SAN MATEO-FOSTER CITY SCHOOL DISTRICT FACILITIES AND CONSTRUCTION ADDENDUM NO.2

Date: May 6, 2026

**Project: FIESTA GARDENS/TURNBULL CHILD DEVELOPMENT CENTER FIRE ALARM
UPGRADE**

Bid No.: 26-07

FA0.1

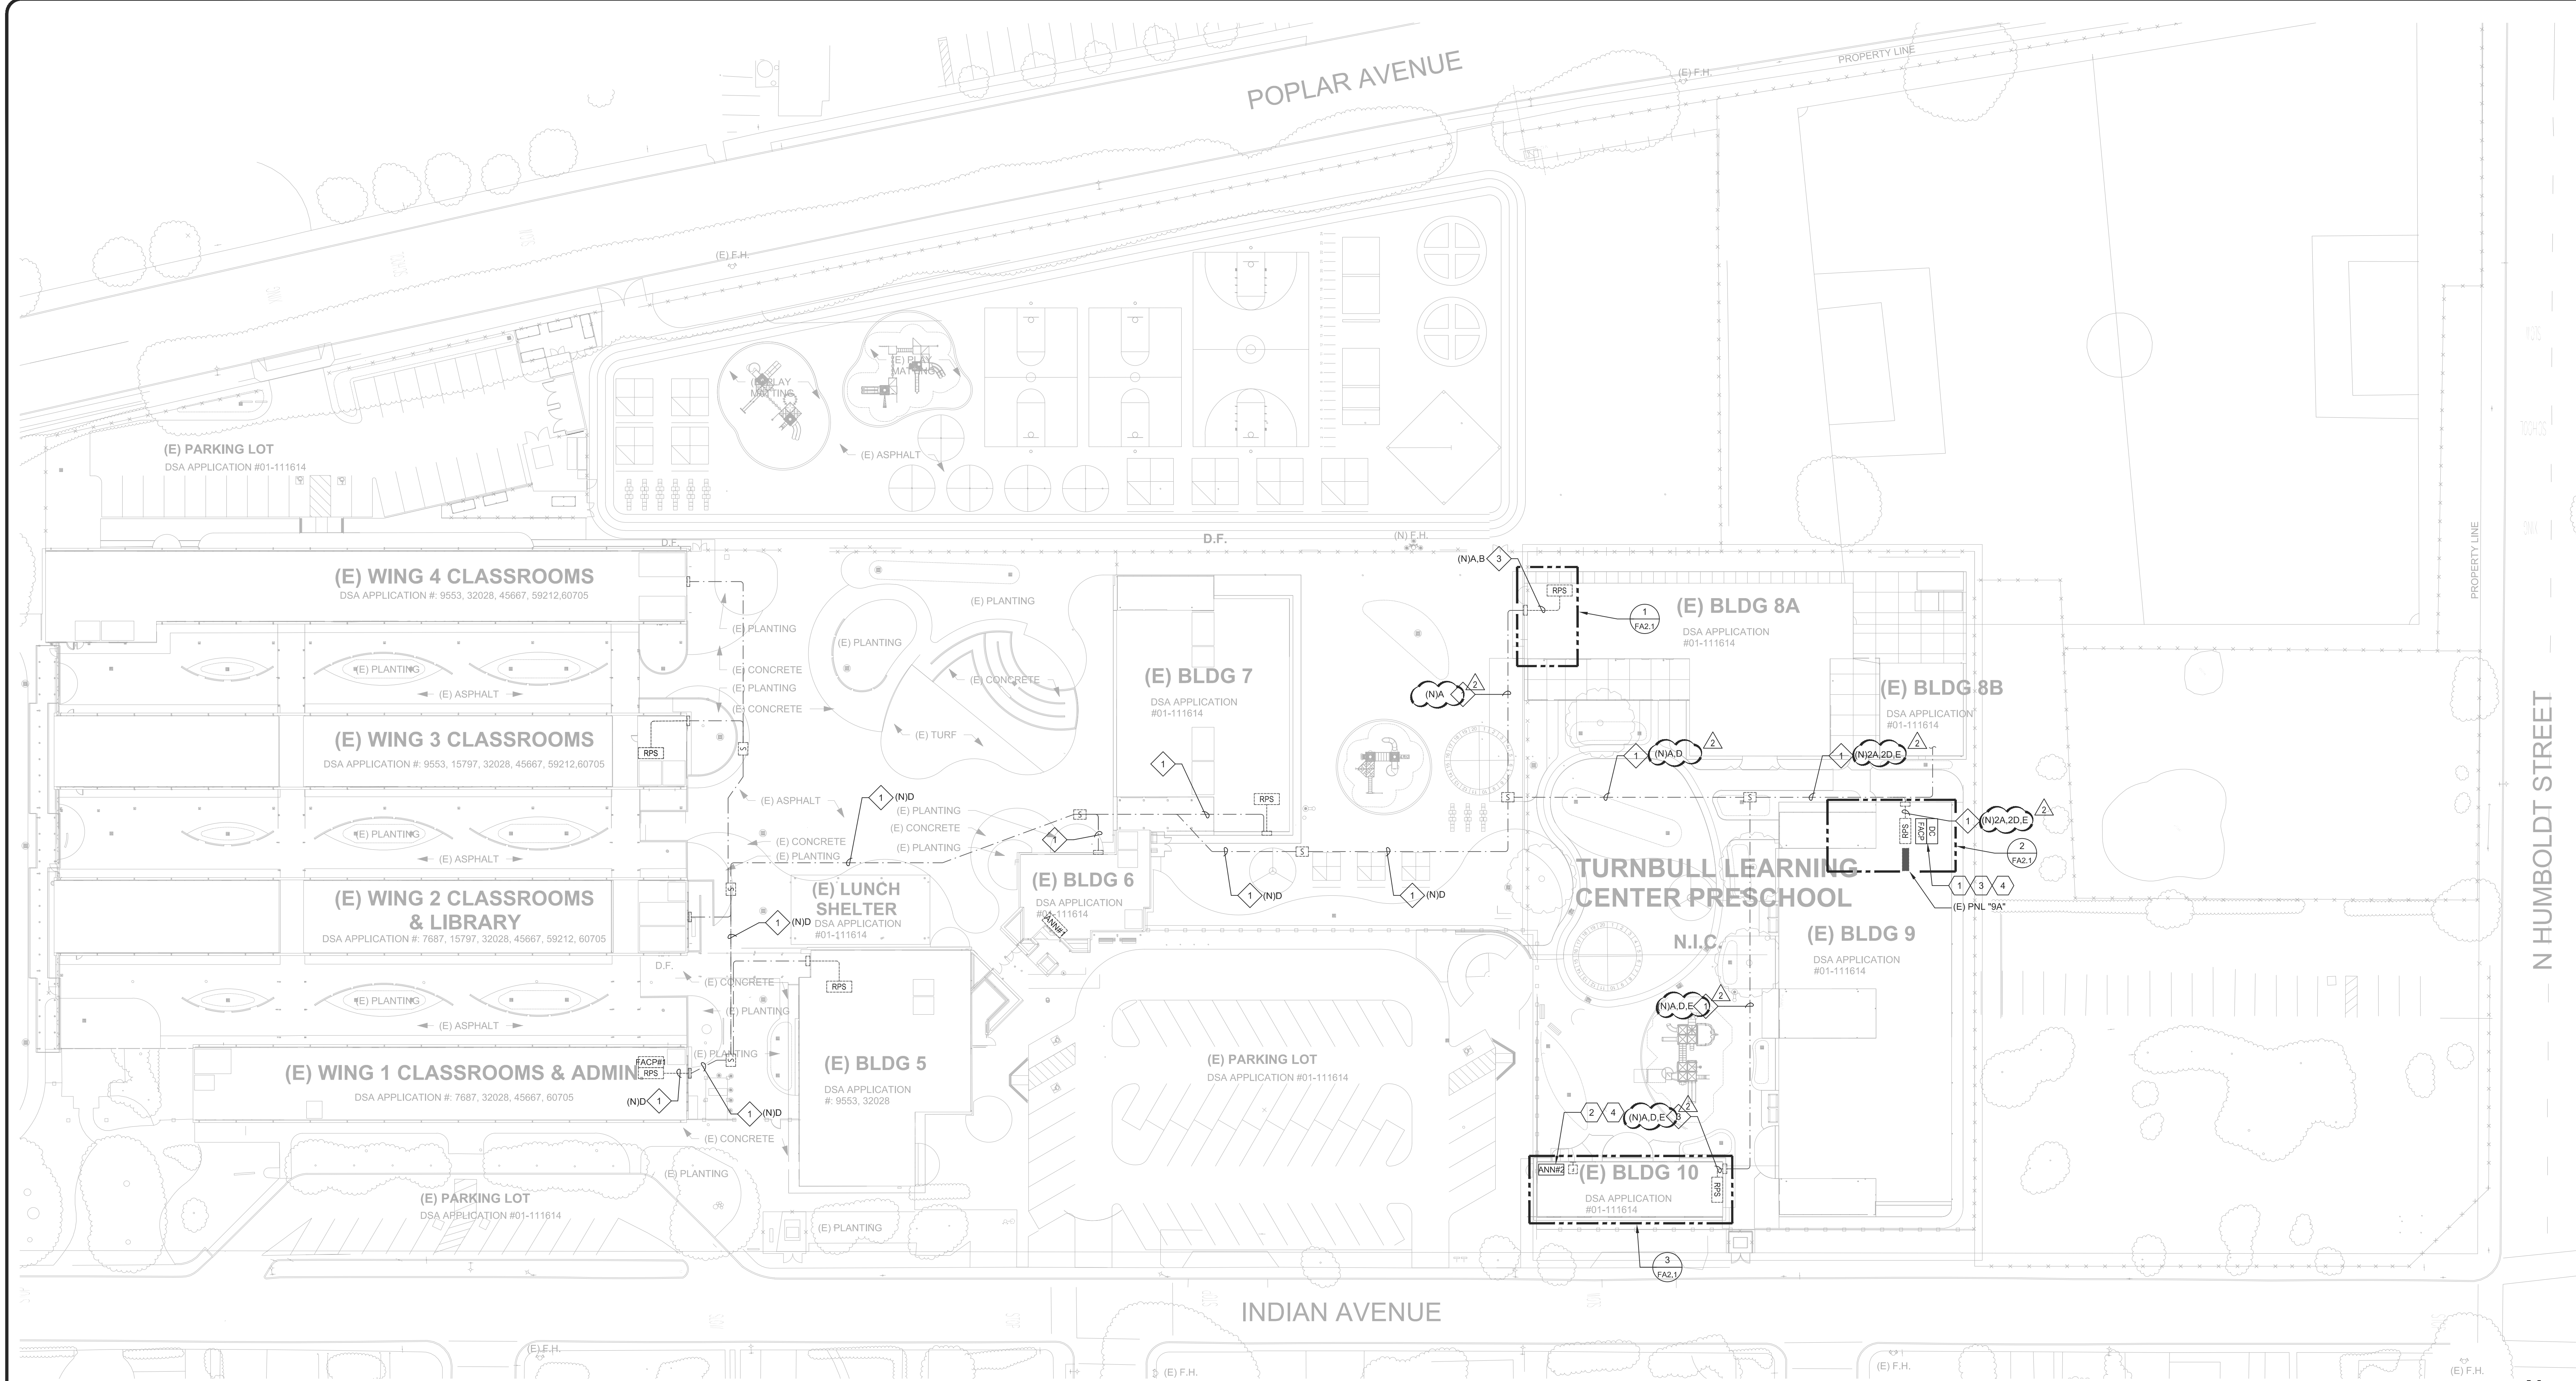
Reference: Drawing FA0.1 FIRE ALARM COVER SHEET

1. Removed Notifier DVC-EM Digital Voice Command Module and DVC-KD Key Board from equipment schedule.
2. Added programming and testing notes.

PROGRAMMING & TESTING NOTES:

- CONTRACTOR TO RE-PROGRAM ALL EQUIPMENT, INITIATING AND NOTIFICATION DEVICES LOCATED IN THE TURNBULL SCHOOL SIDE TO OPERATE INDEPENDENTLY IN THE TURNBULL CAMPUS.

- CONTRACTOR TO RE-PROGRAM ALL EQUIPMENT, INITIATING AND NOTIFICATION DEVICES LOCATED IN THE FIESTA GARDENS SCHOOL SIDE TO OPERATE INDEPENDENTLY IN THE FIESTA GARDENS CAMPUS.

- CONTRACTOR TO RE-PROGRAM BOTH TURNBULL CAMPUS AND FIESTA GARDENS CAMPUS' SYSTEM SHALL BE MONITORED BY THE EXISTING U.L. LISTED CENTRAL MONITORING STATION AT THE SAME TIME AND SEND SIGNAL VIA EXISTING DIALER/TRANSMITTER FROM THE EXISTING FACP AT THE FIESTA GARDENS CAMPUS SIDE TO EXISTING U.L. LISTED CENTRAL MONITORING STATION.

- CONTRACTOR TO FINAL TEST FIRE ALARM SYSTEM WITH ALL INITIATING AND NOTIFICATION DEVICES FOR TURNBULL SCHOOL CAMPUS. PROVIDE TEST REPORT TO SCHOOL, DISTRICT AND ENGINEER FOR RECORD.

- CONTRACTOR TO FINAL TEST FIRE ALARM SYSTEM WITH 10% OF INITIATING AND NOTIFICATION DEVICES IN EACH BUILDING FOR FIESTA GARDENS SCHOOL CAMPUS. PROVIDE TEST REPORT TO SCHOOL, DISTRICT AND ENGINEER FOR RECORD.
